Which? HQ

LISTED BUILDING
BASEMENT PLAN
PROPOSED

ASK-064

REVISION 02 AMENDMENTS INCLUDE:

1 Listed Building Basement Services Plan - Proposed

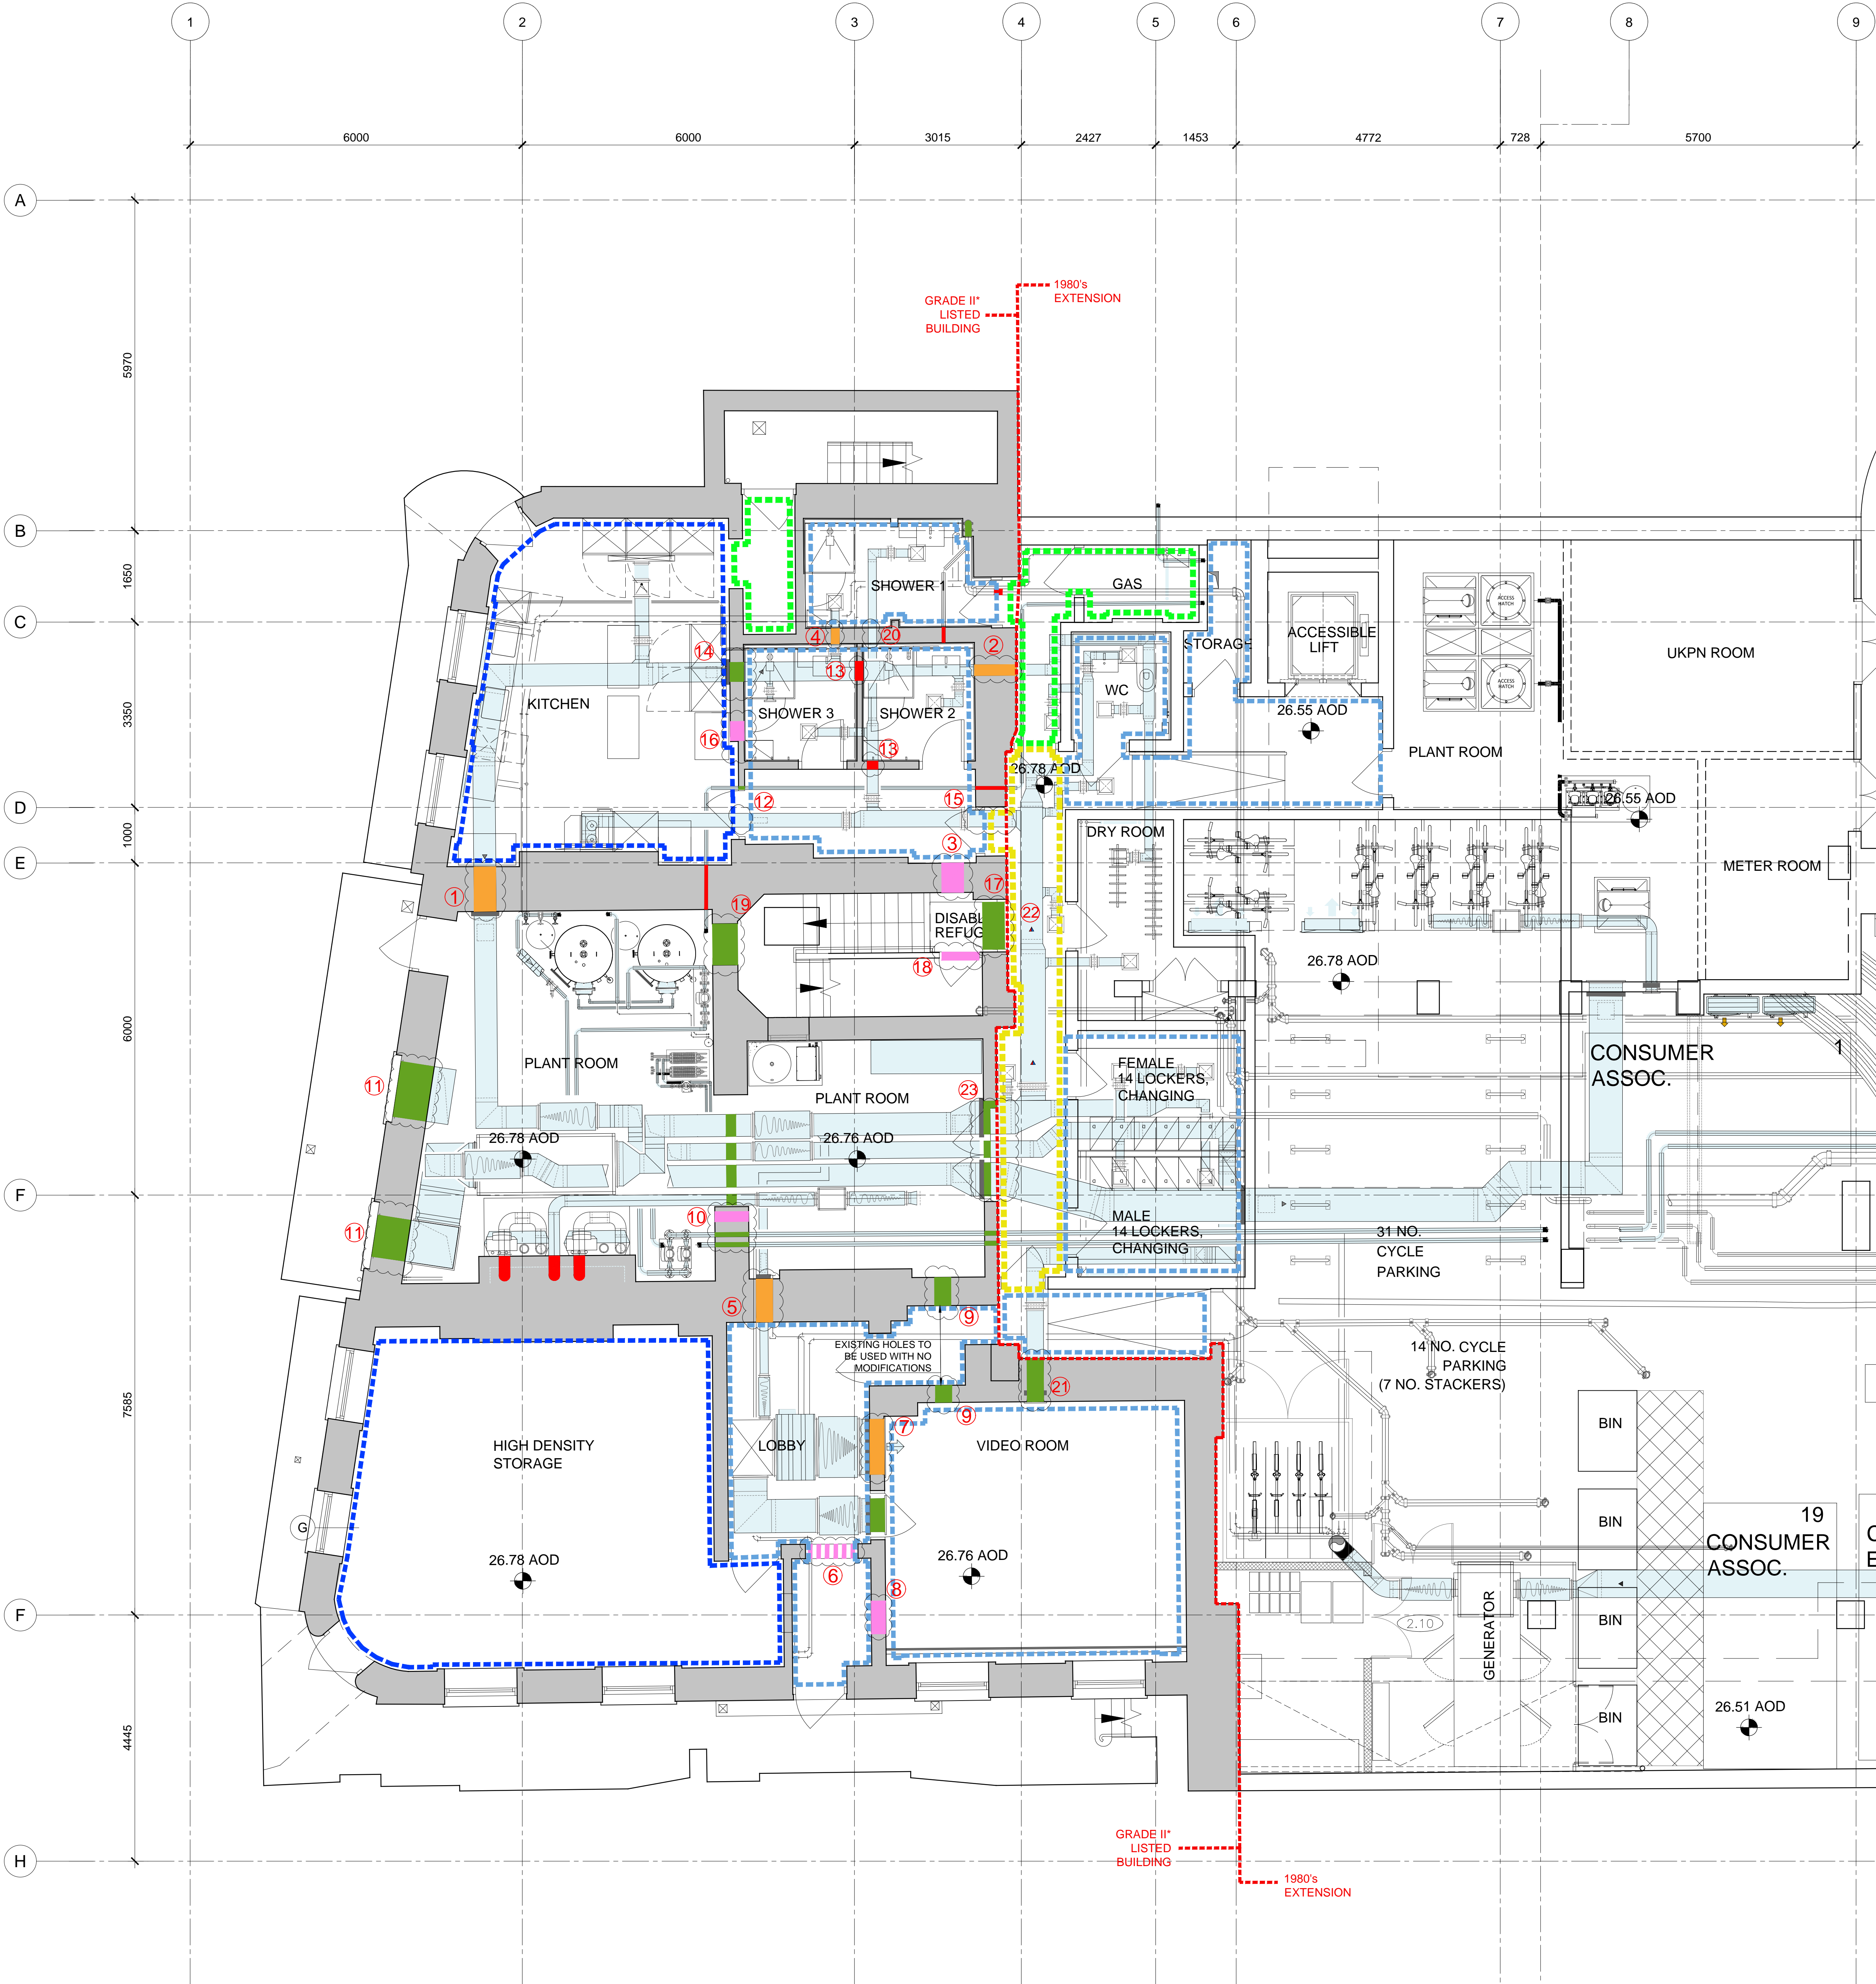
- 1 NO. BUILDERS WORK HOLE ALREADY HAS PLANNING CONSENT -- HOLE IS TO BE SLIGHTLY ENLARGED TO SUIT THE WORKING BUILDERS WORK DETAIL FOR THE MANUFACTURER OF THE FIRE DAMPER USED BY THE ME&E SUB CONTRACTOR IN THIS LOCATION. HOLE TO BE INCREASED IN SIZE TO 600MM WIDE STRUCTURAL OPENING.

- 1 NO. BUILDERS WORK HOLE ALREADY HAS PLANNING CONSENT -- HOLE IS TO BE SLIGHTLY ENLARGED TO SUIT THE WORKING BUILDERS WORK DETAIL FOR THE MANUFACTURER OF THE FIRE DAMPER USED BY THE ME&E SUB CONTRACTOR IN THIS LOCATION. HOLE TO BE INCREASED IN SIZE TO 400MM WIDE STRUCTURAL OPENING.

- 1 NO. BUILDERS WORK HOLE TO BE FORMED -- HOLE SIZE TO BE 525MM WIDE STRUCTURAL OPENING. HOLE HAS BEEN INTRODUCED AS A PATH WAS NEEDED THROUGH THE STAIR BUT THE ADJACENT CORRIDOR IS TOO FULL OF OTHER SERVICES, REQUIRING THIS ROUTE.

- 1 NO. BUILDERS WORK HOLE ALREADY HAS PLANNING CONSENT -- HOLE TO BE INCREASED IN SIZE TO 200MM WIDE STRUCTURAL OPENING. HOLE WAS MODIFIED TO AN EXISTING PENETRATION #16 AND TO SUIT THE BUILDERS WORK DETAIL FOR THE MANUFACTURER OF THE FIRE DAMPER USED BY THE ME&E SUB CONTRACTOR IN THIS LOCATION.

- 1 NO. BUILDERS WORK HOLE ALREADY HAS PLANNING CONSENT -- HOLE IS TO BE SLIGHTLY ENLARGED TO SUIT THE WORKING BUILDERS WORK DETAIL FOR THE MANUFACTURER OF THE FIRE DAMPER USED BY THE ME&E SUB CONTRACTOR IN THIS LOCATION. HOLE TO BE INCREASED IN SIZE TO 425MM WIDE STRUCTURAL OPENING.

- 6 NO. BUILDERS WORK HOLES TO BE FORMED -- DUE TO HOLE #7 DIVIDING INTO TWO DIFFERENT HOLES (#7 AND #8), A NEW RETURN AIR PATH INTO THE BACK OF THE FCU IS NEEDED IN ORDER TO MAINTAIN THE SAME VENTILATION PRINCIPALS. EACH HOLES BE SIZED AT 125MM DIA. CORE HOLES.

- 1 NO. BUILDERS WORK HOLE ALREADY HAS PLANNING CONSENT -- DUE TO STRUCTURAL INTEGRITY, THE HOLE IS TO BE REDUCED IN SIZE TO 500MM WIDE STRUCTURAL OPENING. SERVICES ARE THEREFORE SPLIT INTO TWO SMALLER HOLES (HOLE #7 AND HOLE #8) IN ORDER TO PROVIDE THE SAME COMFORT CONDITIONS IN THE VIDEO ROOM.

- 1 NO. BUILDERS WORK HOLE TO BE FORMED -- SIZE TO BE 500MM WIDE STRUCTURAL OPENING. NEW HOLE REQUIRED TO ALLOW RETURN AIR FROM THE ROOM BACK TO THE FCU SERVING THE ROOM.

- EXISTING PENETRATIONS TO BE USED AND NOT MODIFIED.
- EXISTING OPENINGS IN THIS LOCATION ARE NOT ABLE TO BE REUSED. NEW OPENING ADJACENT IS TO BE FORMED. NEW OPENING INTRODUCED AS SERVICES ARE REQUIRED TO PASS OVER THE DOOR WITHIN THE PLANTROOM FOR COORDINATION. EXISTING OPENING TO BE INFILLED AND DRY PACKED.

- EXISTING OPENINGS ENLARGED ONLY IN 1980s BLOCKWORK.
- PLANNING CONSENTED PENETRATION IN THIS LOCATION CANNOT BE FORMED DUE TO EXISTING STEEL BEAM. NOT REQUIRED.

- PLANNING CONSENTED PENETRATIONS (REV 00) THROUGH MODERN STUD PARTITIONS ONLY.
- EXISTING HOLE IN THIS LOCATION TO BE REUSED.
- PROPOSED HOLE IN THIS LOCATION (REV 00) CANNOT BE FORMED AND THEREFORE MOVES ELSEWHERE.

- EXISTING PENETRATION IN THIS LOCATION IS NOT SUFFICIENT FOR REUSE. A NEW PENETRATION IS TO BE FORMED AT 350MM WIDE STRUCTURAL OPENING.
- 1 NO. EXISTING PENETRATION TO BE REUSED.

- 1 NO. NEW HOLE TO BE FORMED IN THIS LOCATION THROUGH MODERN STUD PARTITION TO ALLOW FOR INCORPORATION OF ACCESS DOOR AND ACCESS TO EXISTING MANHOLE BENEATH STAIRS.

- 1 NO. EXISTING PENETRATION THROUGH BLOCKWORK WALL TO BE INFILLED.
- CONSENTED PENETRATION IN THIS LOCATION IS NO LONGER REQUIRED.
- EXISTING HOLE IN THIS LOCATION NO LONGER REQUIRED FOR REUSE.

- MODERN DOOR TO LISTED BUILDING STAIRWELL TO BE UPGRADED TO ALIGN WITH FIRE STRATEGY AND BUILDING CONTROL REQUIREMENT FOR 30 MIN FIRE RATING WITH SMOKE SEALS AND SELF CLOSING DEVICE.

- MODERN DOOR TO LISTED BUILDING PLANT ROOM TO BE UPGRADED TO ALIGN WITH FIRE STRATEGY AND BUILDING CONTROL REQUIREMENT FOR 30 MIN FIRE RATING WITHOUT SMOKE SEALS AND INCLUSION OF 'FIRE DOOR KEEP LOCKED' SIGNAGE.

NOTE, DRAWING SHOWS MINOR ADJUSTMENTS TO CEILING TREATMENT IN ROOMS UNDERGOING WORKS WITHIN THE LISTED BUILDING.

NOTE, ADDITIONAL SMALL DIAMETER CORES (75MM DIA. OR SMALLER) WILL BE REQUIRED FOR DOMESTIC PIPEWORK, BUT LOCATIONS NOT SHOWN ON THIS SKETCH.
